Planning and Zoning Commission

February 5, 2020 – REGULAR MEETING

TOWN OF JACKSON PLANNING COMMISSION AGENDA DOCUMENTATION

SUBJECT: **ITEM P19-262:** AMENDMENT TO THE FINAL (MAJOR) DEVELOPMENT PLAN FOR PINE GLADES PLANNED UNIT DEVELOPMENT (PUD).

PINE GLADES
JACKSON, WYOMING
TRAIL CONCEPT PLAN
NORTHEAST SEGMENT

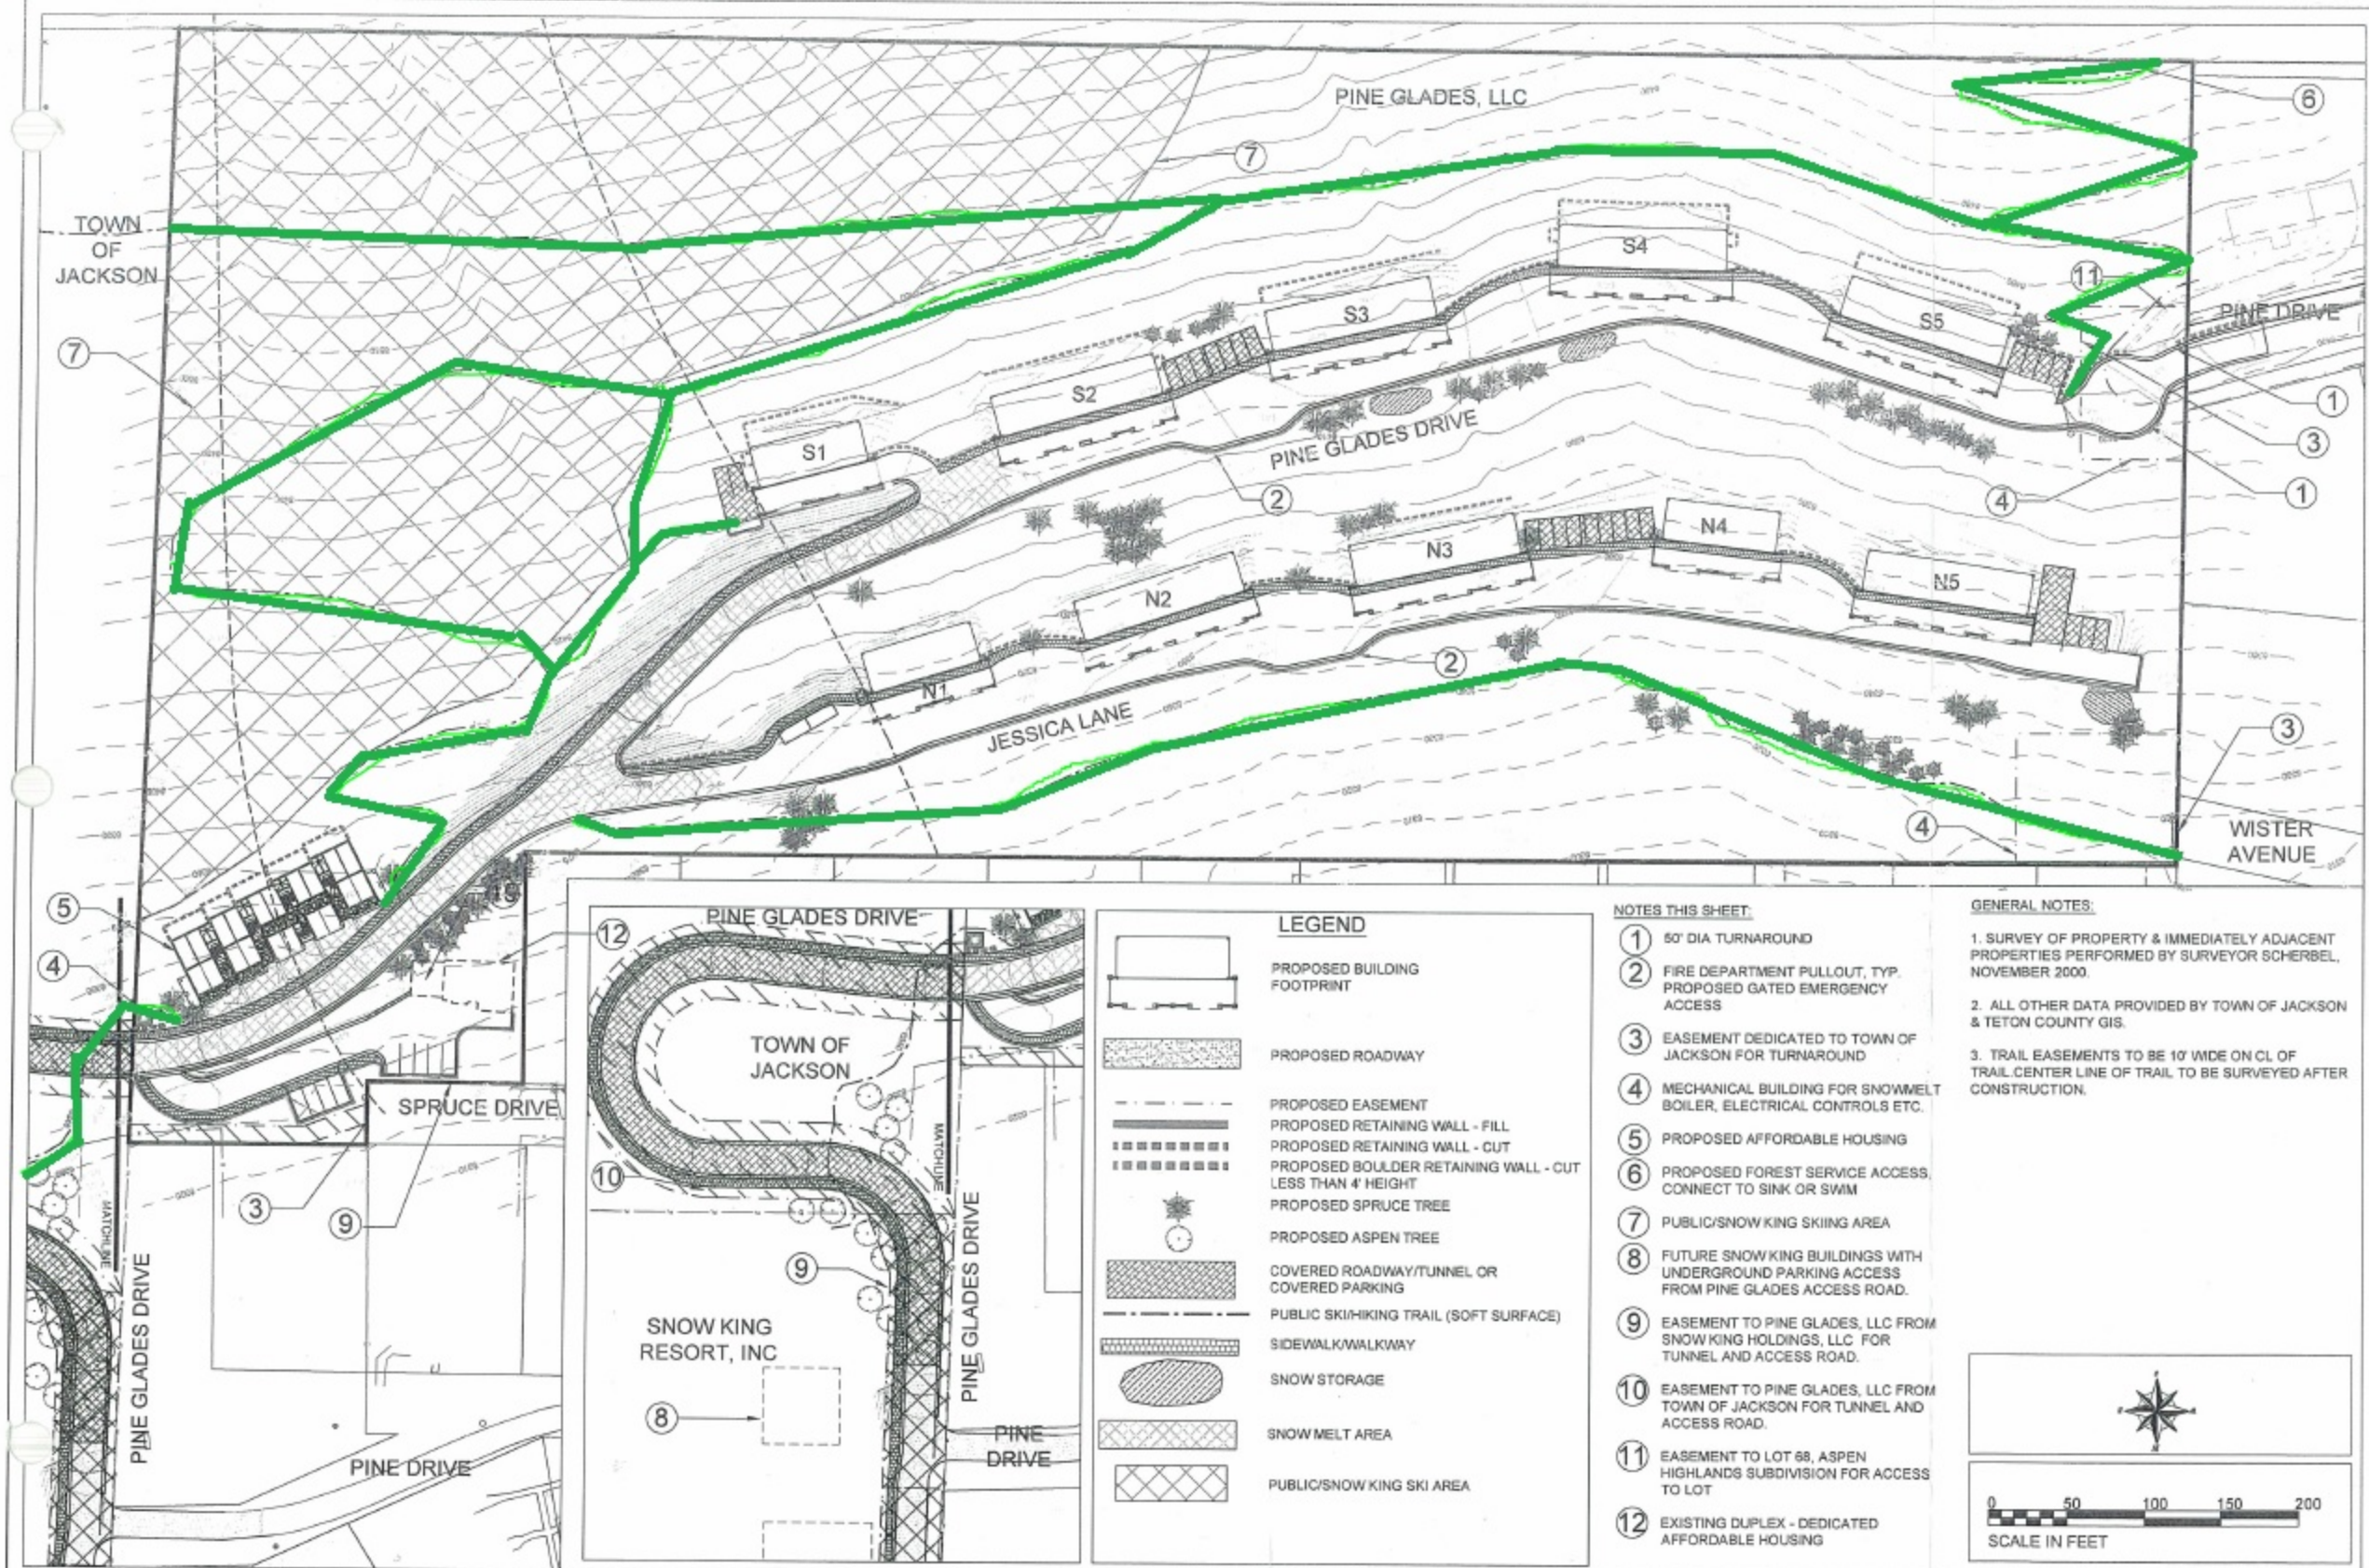
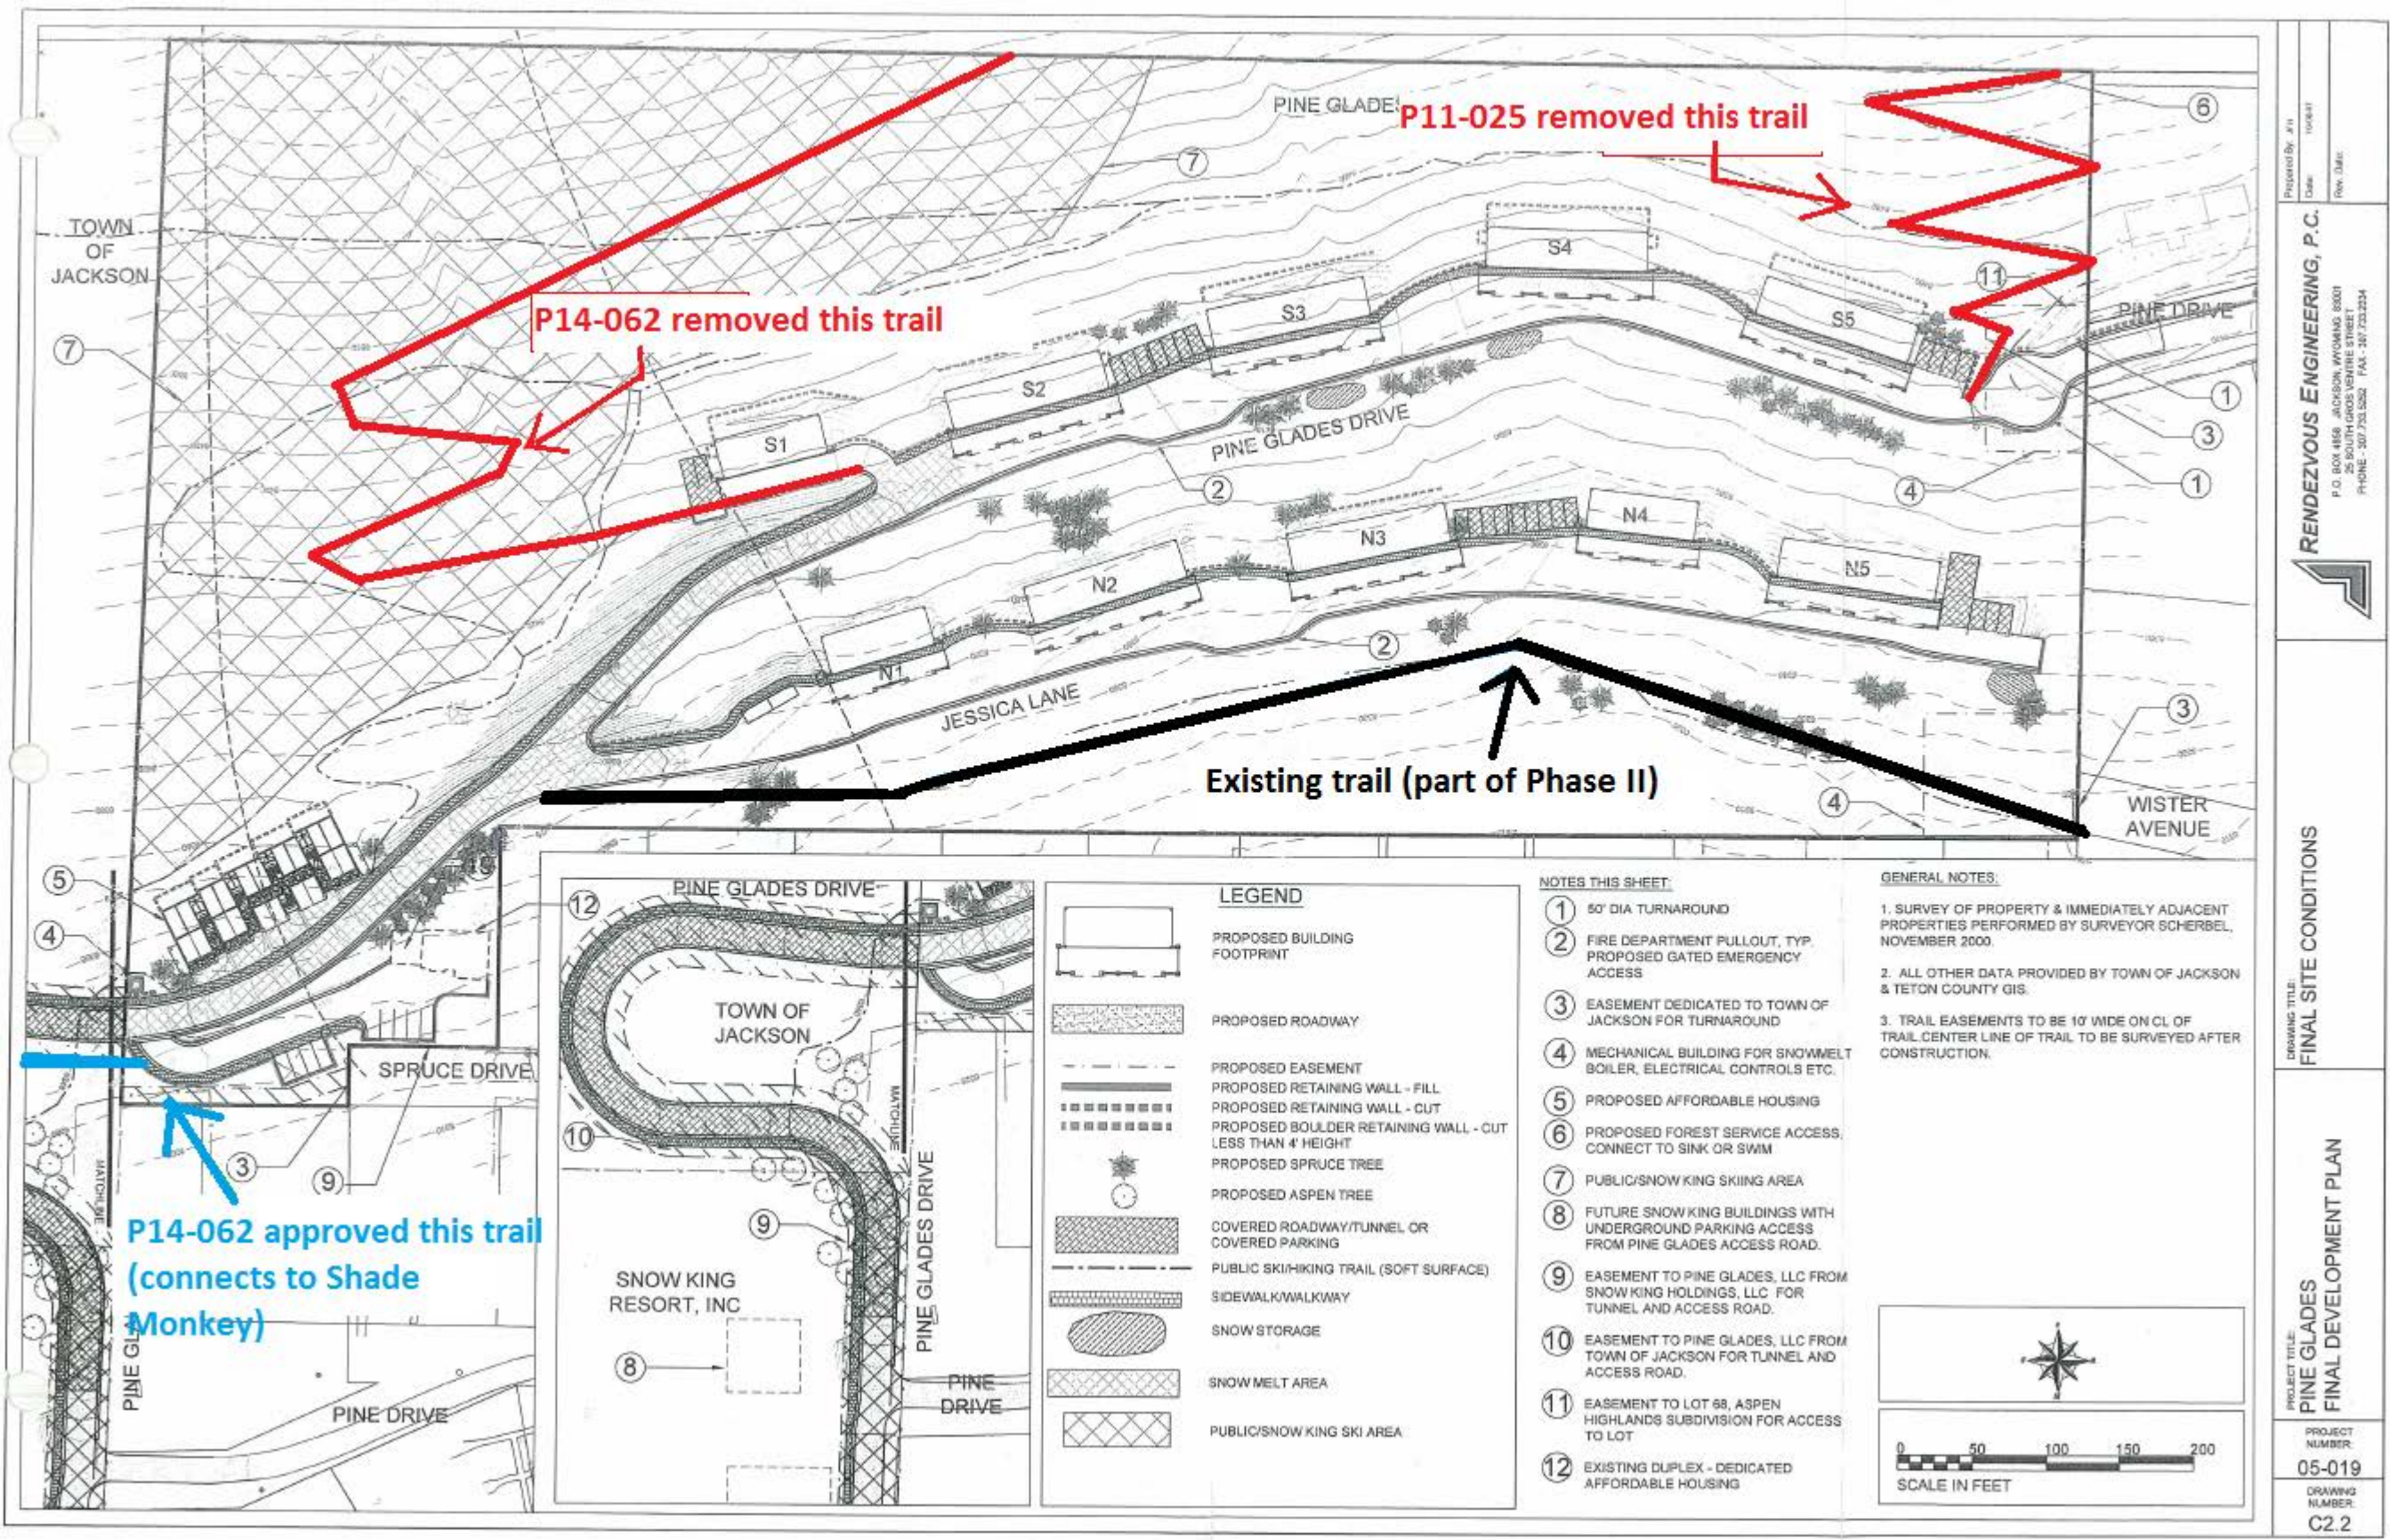
One attached alternative avoids the downhill turn adjacent to the duplex and continues the trail along the side of Pine Glades Drive to where it reaches an existing parking lot, and then the trail wraps around the parking and continues east. Attached are a plan view showing this alignment and a cross-section depicting how the alternative relates to the retaining wall at the head of the parking lot.

January 31, 2019 comments in response to alternative trail plan					
•While the revised trail provides essentially the same connectivity (start and end points) and I feel it meets the intent of the trail connection, it’s not as nice a trail route for the users as it will be butt up against a retaining wall for much of the route and a 5’ attached sidewalk for the rest, neither of which is a great trail design. The new route is a little more direct and has fewer stairs (although essentially the same overall vertical drop and gain), but overall the original route was a better design. So, I feel it’s acceptable but a step down from the originally proposed route.					
Planning Tyler Valentine (1/10/2020 9:42 AM TV) Please see staff report	APPROVED W/CONDITI	11/14/2019	12/9/2019	1/10/2020	
Police Todd Smith (12/9/2019 8:39 AM STOL) Great to see a commitment to get the hiking trails reestablished by the applicant. It is not uncommon for the police to received complaints regarding this issue from the public wanting access.	APPROVED W/CONDITI	11/14/2019	12/9/2019	12/9/2019

4. The applicant shall satisfactorily address all concerns from the Pathways Director related to technical or engineering suggestions for the trails. Comments related to neighbor approval or unspecified ongoing concerns are not the responsibility of the applicant.
5. The applicant shall make all efforts to not disturb mature Spruce trees in the section of the trail below the cul-de-sac. Any necessary removal of trees will require new trees to be planted to ensure adequate screening is maintained. All new trees will require approval from the Fire Department and Planning Department.
6. The alternative trail route for Section #3 that goes above the duplex and hugs the parking area on Pines Glades Drive shall be the approved trail alignment.
